Explanation of Request: Site Plan and Design Approval of 500 key hotel

Re: Preliminary Site Plan and Design Review for 500-key Hotel / File No. 23-DP-49/ Applicants' Responses

This response letter is being submitted on behalf of the Applicants, HFL Landings Owner, LLC and Landings Venture, LLC (collectively, the "Applicants") for the Diplomat Landings Site Plan Design review approval for the 500-key hotel. By this letter, we are providing responses to the Preliminary Site Plan and Design Review Committee Report identified at File No. 23-DP-49.

AMENITY LEVEL

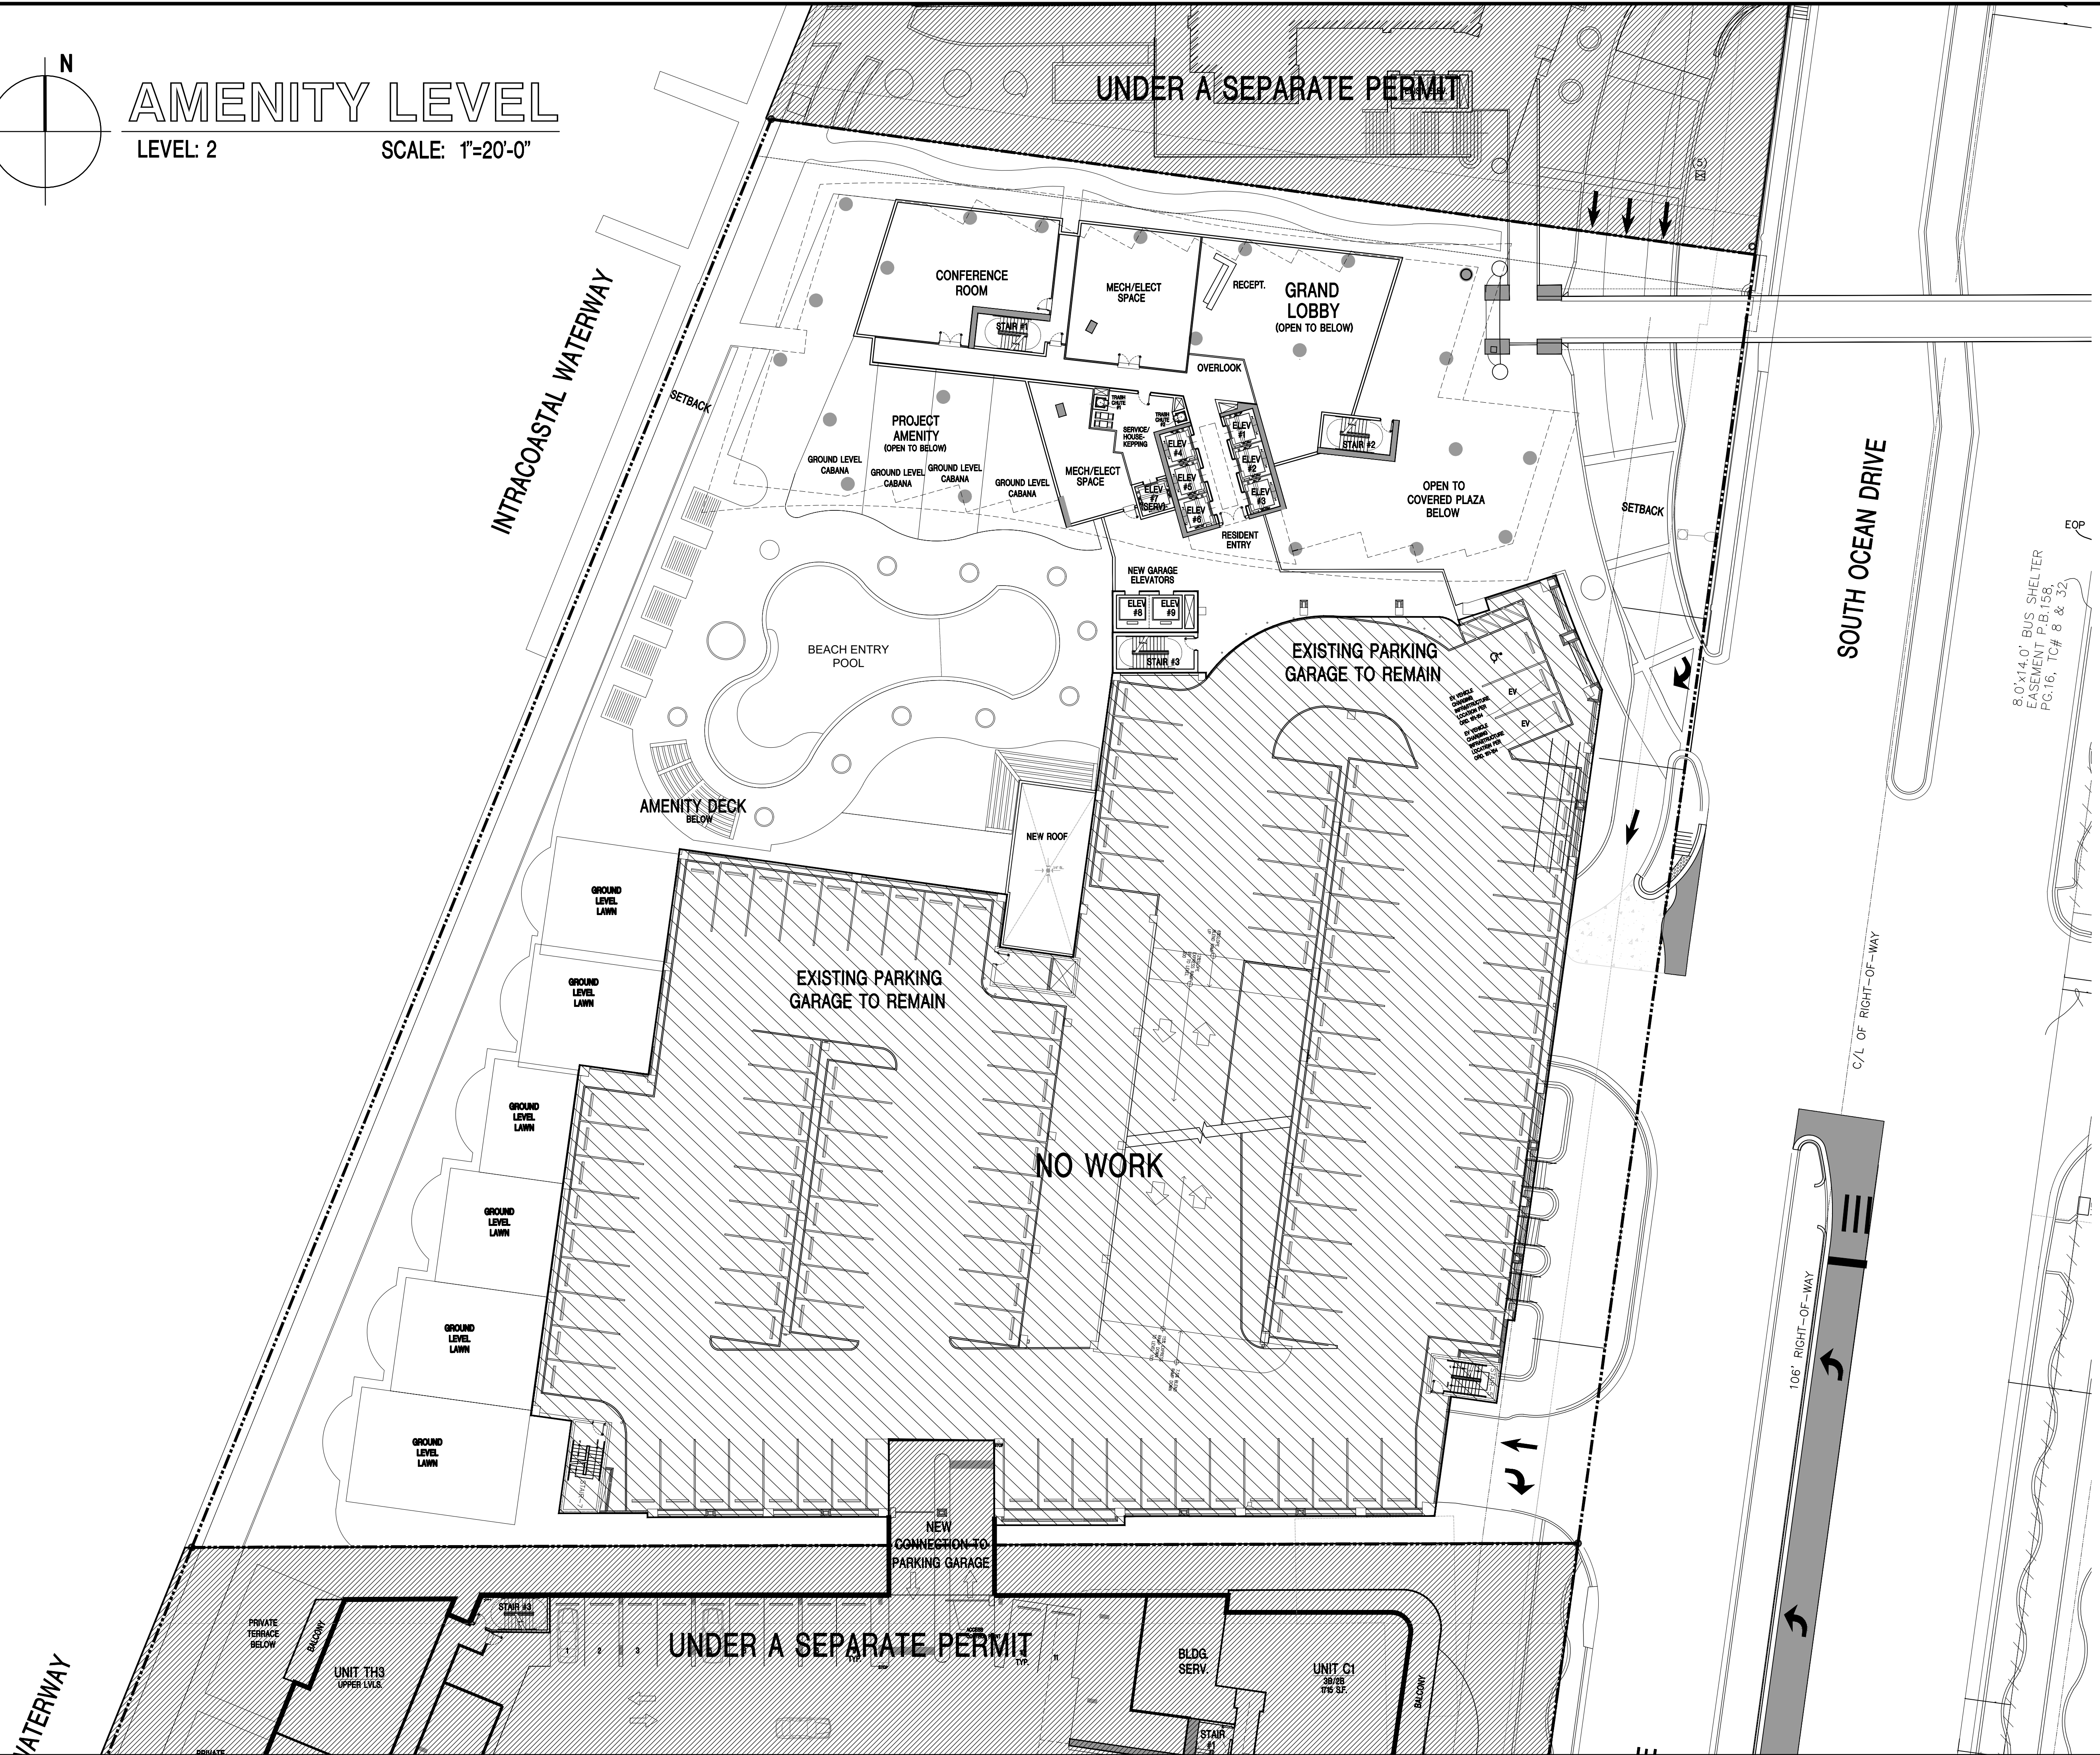
4. Explain the use and function of amenity spaces at levels 2-4 of Architectural sheets.

3. Indicate on the site plan where the infrastructure necessary for future installation of electric vehicle-charging equipment will be located. (See 151.154, Ordinance O-2016-02) Consider placing it adjacent to a handicapped space so that the future charger will be accessible from both types of spaces.

Response: Amenity descriptions have been provided. See sheets A2.1, A2.2.

Response: Although we do not believe this is applicable because the parking garage is existing, we are providing 2 Electrical vehicle spaces. See Sheet A2.1.

A2.3

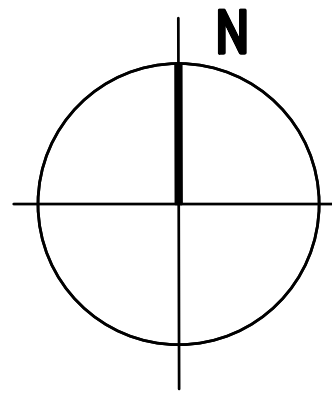
2. Sheet A2.3

a. Tower Label indicates hotel rooms will be located on floors 5-43; however, elevations show the top floor as 42. Reconcile.

b. Identify the types of easements (e.g., utility easement).

- c. What will be located on the roof?

- d. Ensure that all easements, setback and other instruments are properly reflected on the elevations (e.g., is the setback 16' or 18'?).

Response: The Tower is only 42 levels. The discrepancy has been revised.

Response: Easements have been labeled.

Response: Mechanical equipment.

Response: Drawings have been revised. The setback as shown on A1.0 is 40 ft.
